**CABINET MEMBER FOR HIGHWAY MANAGEMENT –  
12 OCTOBER 2023**

**LYNEHAM: PROPOSED 20MPH SPEED LIMITS**

Report by Corporate Director, Environment and Place

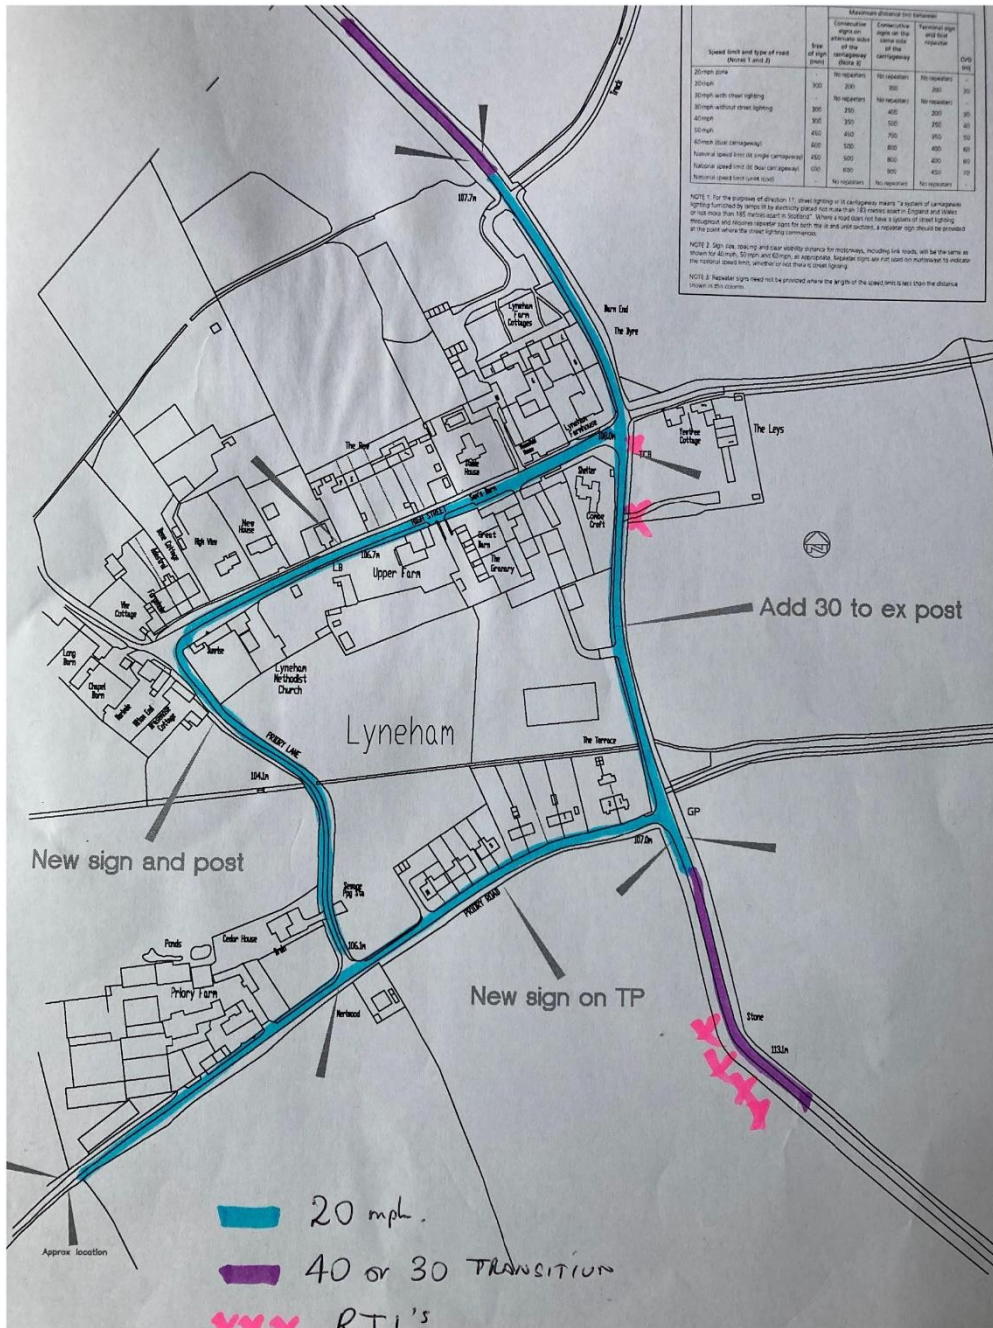
The existing 30 we had understood would be reverting to 20 , it is as you state 16m from the junction, that's too close and would obviously be better displaced further away or again a transition from 60 to 40 or 30 prior to the bend.

Once again the existing sign obstructs the Priory road junction sight line and reduces verge cutting to hand operations.

The high speed approach has seen countless accidents for vehicles leaving the road at the bend and taking out the chevrons .

It's preceded erroneously by a signpost as a double bend - it's not

It's a single bend if supplemented with a reduce speed it might help.

Our preference would be as below
